MOOLARBEN COAL COMPLEX OC3 EXTENSION PROJECT

SECOND AMENDMENT REPORT

APRIL 2026

Plate 1-1: Recommended Additional Habitat Enhancement Areas ‘Sketched’ by the IEAPM

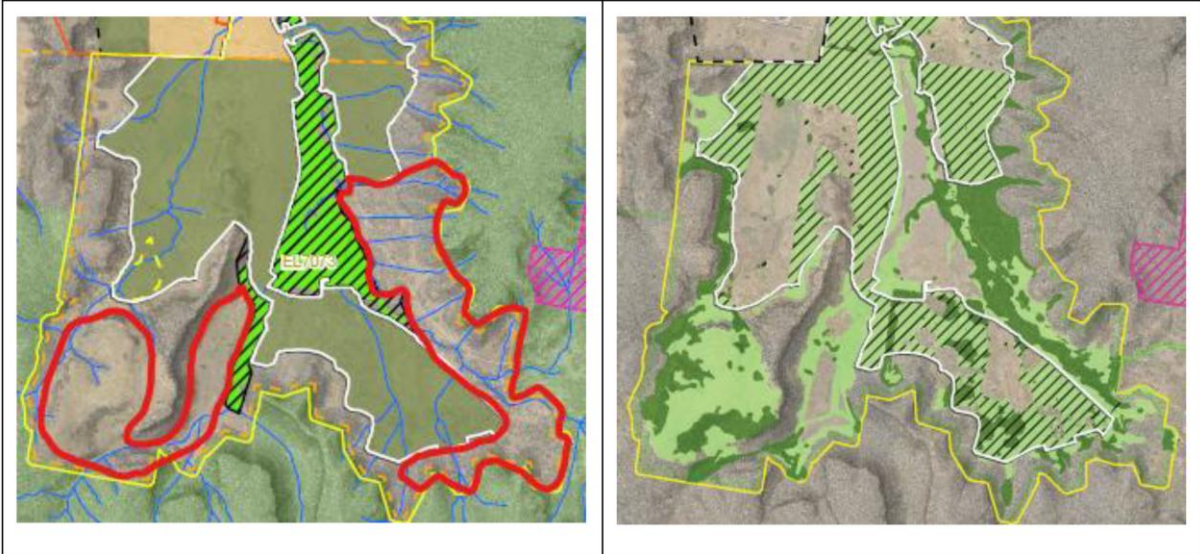
However, the draft conditions as proposed by DPHI would further extend the Habitat Enhancement Area to include recommended additional areas sketched by the IEAPM in its Advice Report (IEAPM, 2025a) (refer to Figure 7 of the IEAPM Advice Report, reproduced below as Plate 1-1).

- The recommended additional areas were suggested by the IEAPM to provide an equivalent area of Box-Gum Woodland Critically Endangered Ecological Community (CEEC) to that within the disturbance footprint (i.e. approximately 401 ha). However, upon review by MCO, it has been identified the recommended additional areas contain only approximately 196 ha of Box-Gum Woodland CEEC. Therefore, more area is required to satisfy the equivalence statement.

To address ambiguity with the recommended additional areas sketched by the IEAPM, MCO has refined the areas to align with MCO property and tenement boundaries (i.e. to avoid any overlap with the Munghorn Gap Nature Reserve) and the Project disturbance footprint. This is represented by the black hatched area on Figure 2-1 and contains approximately 235 ha of Box-Gum Woodland CEEC (i.e. a total of 343 ha inclusive of the Habitat Enhancement Area as previously [2024] proposed) (Figure 2-2).

Habitat Enhancement Area as Previously Proposed and Proposed Additional Extent

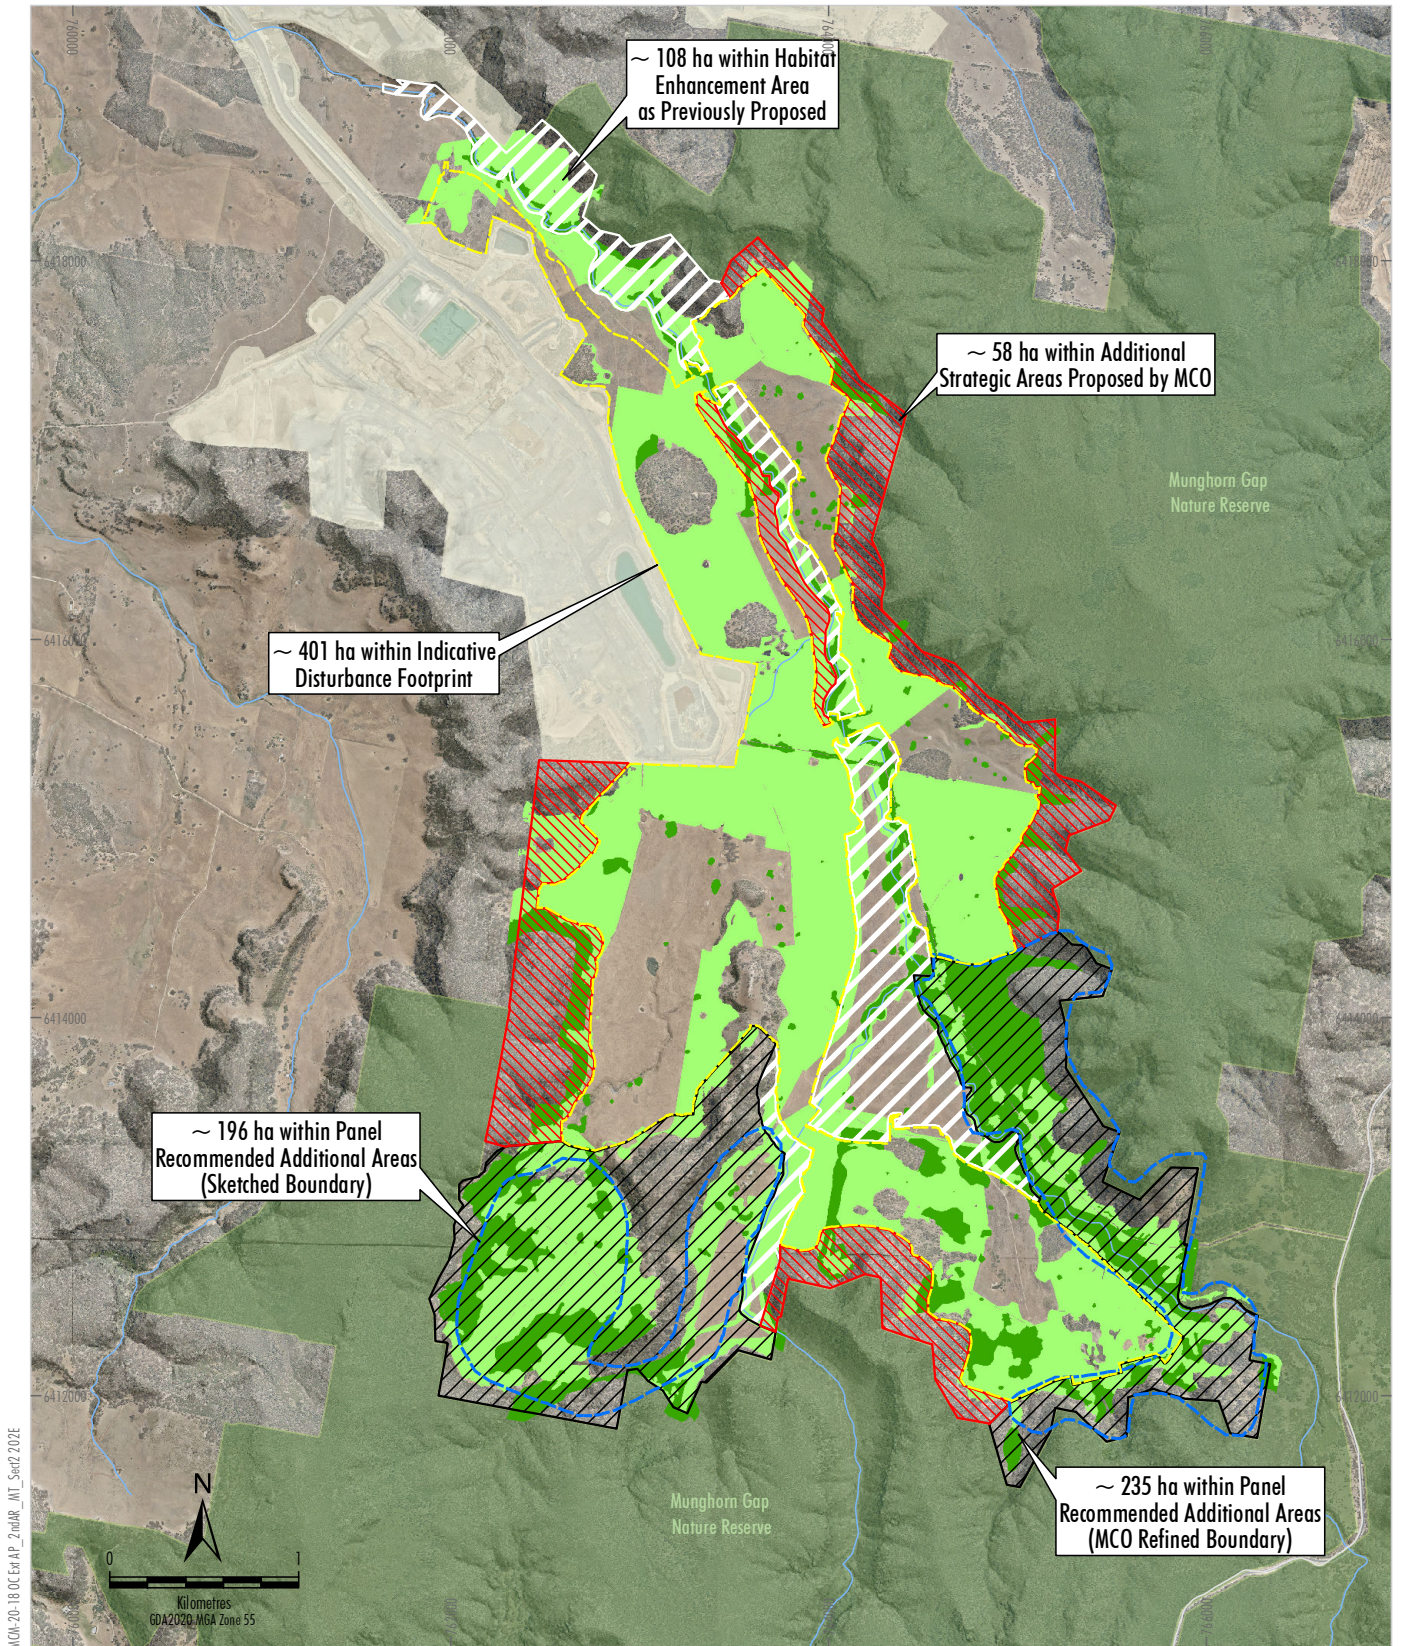
The recommended additional areas identified by the IEAPM are presented as a sketch in the Advice Report (IEAPM, 2025a) (refer to Plate 1-1) and amount to approximately 313 ha in area, which would increase the total Habitat Enhancement Area extent to approximately 501 ha, compared to approximately 188 ha as proposed in previous (2024) Amendment Report. The IEAPM's sketch is shown as the blue dashed outline on Figure 2-1.

To address the shortfall, MCO is proposing to include additional strategic areas around the perimeter of the Project area targeting the buffer between the Project disturbance footprint and the Munghorn Gap Nature Reserve (refer to red hatched areas on Figure 2-1).

Cumulatively, the additional Habitat Enhancement Area extent (i.e. MCO's refined version of the recommended additional areas and the additional strategic areas proposed by MCO) results in an increase to the Habitat Enhancement Area of approximately 625 ha, bringing it to a total of approximately 813 ha (Figure 2-1).

MOOLARBEN COAL COMPLEX
Revised Indicative Mine Progression

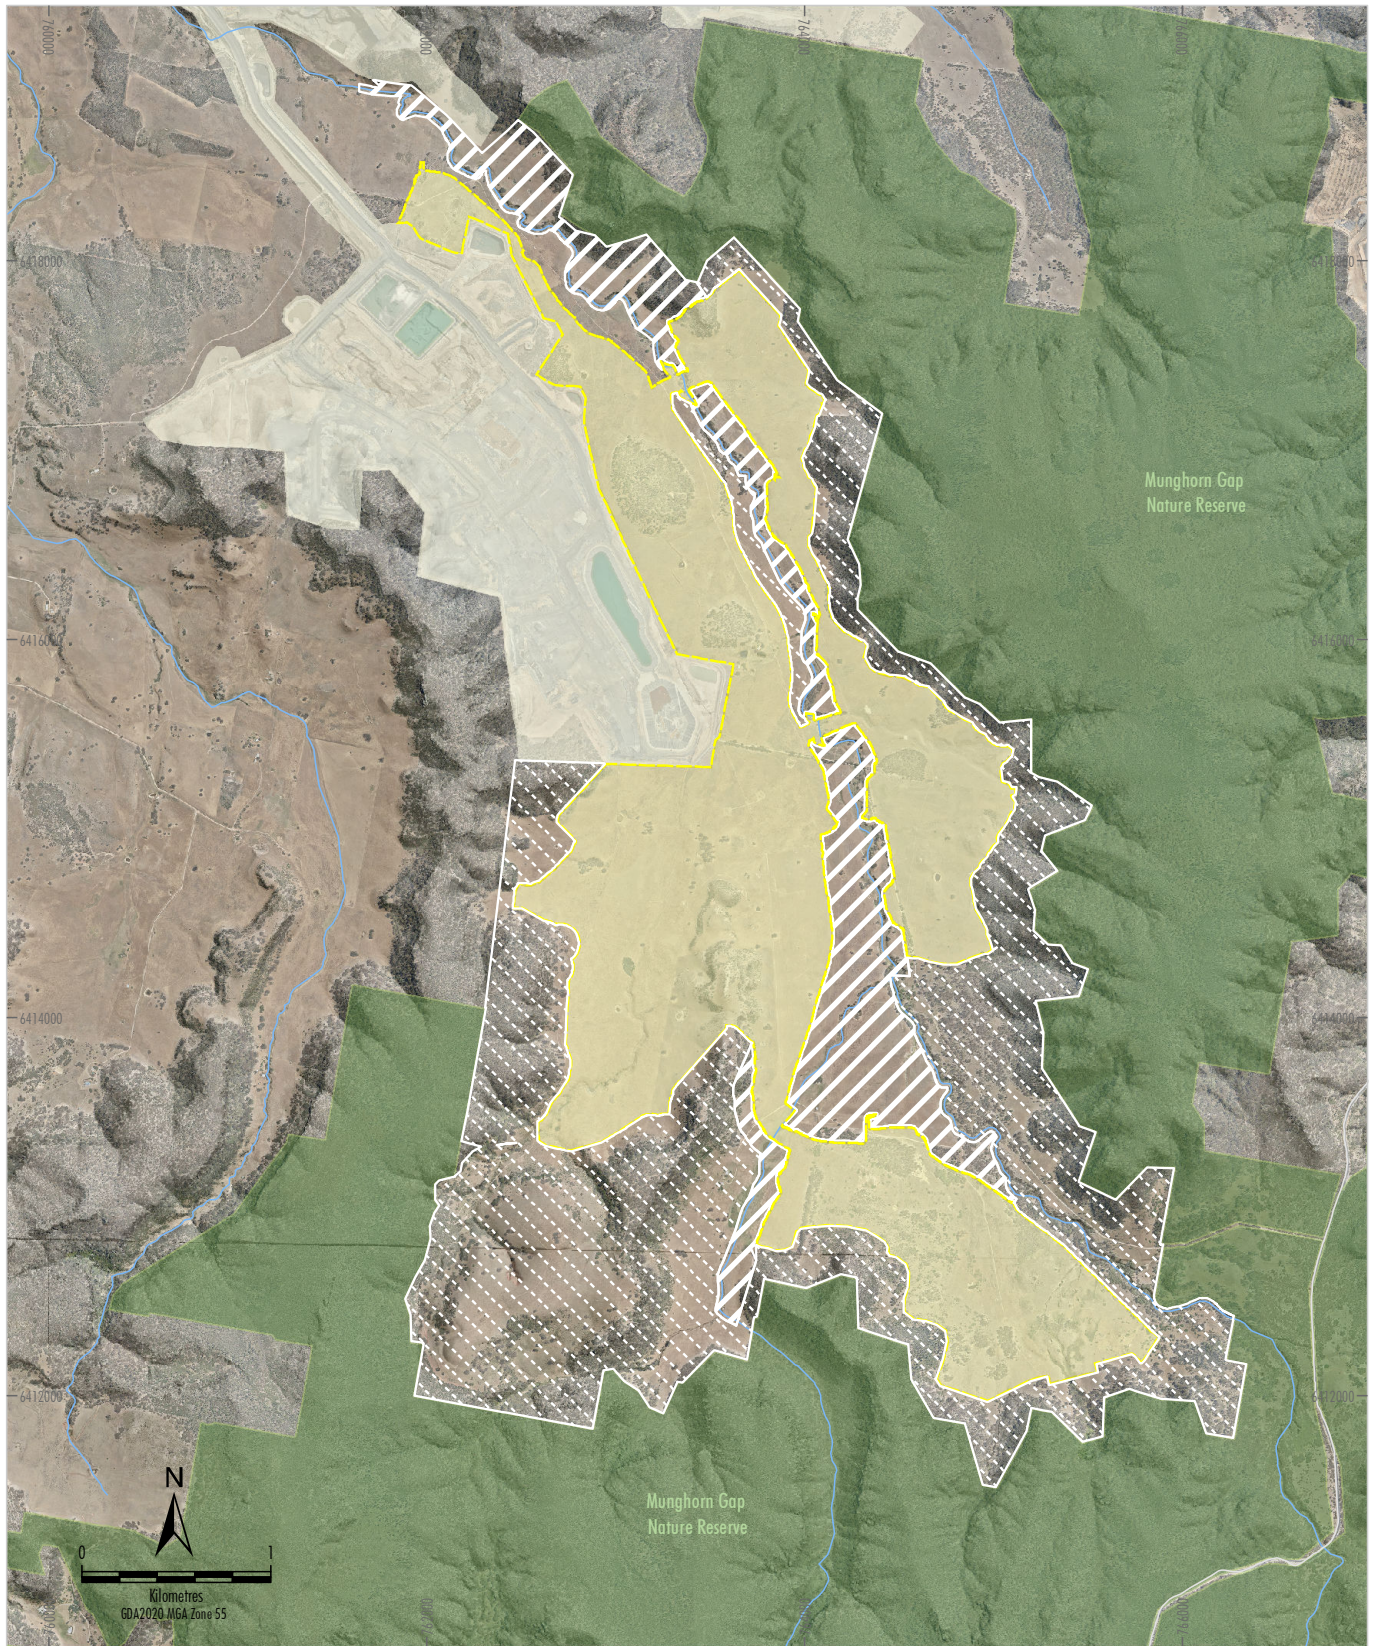
To confirm that MCO's intention is for the Project mining operations to be completed by the end of 2034, MCO is therefore proposing to revise the ROM coal production schedule to reflect mining commencing in 2027 (to allow for the collection of 12 months of baseline data) whilst retaining the previously proposed mining completion date of 2034.

The Project mine life would be shortened from 10 years to 8 years, with an associated revision to the indicative mine schedule, to reflect the delayed mining commencement date of 2027 whilst retaining the previously proposed mining cessation date of 2034. The amended Project would not result in any change to the total ROM coal extraction over the life of the Project (i.e. 30 Mt).

A comparison of the indicative mine schedule for the Project as per the previous (2024) Amendment Report and considering the proposed additional amendments is provided in Table 3-2. The revised indicative mining progression for the Project is shown on Figure 3-1.
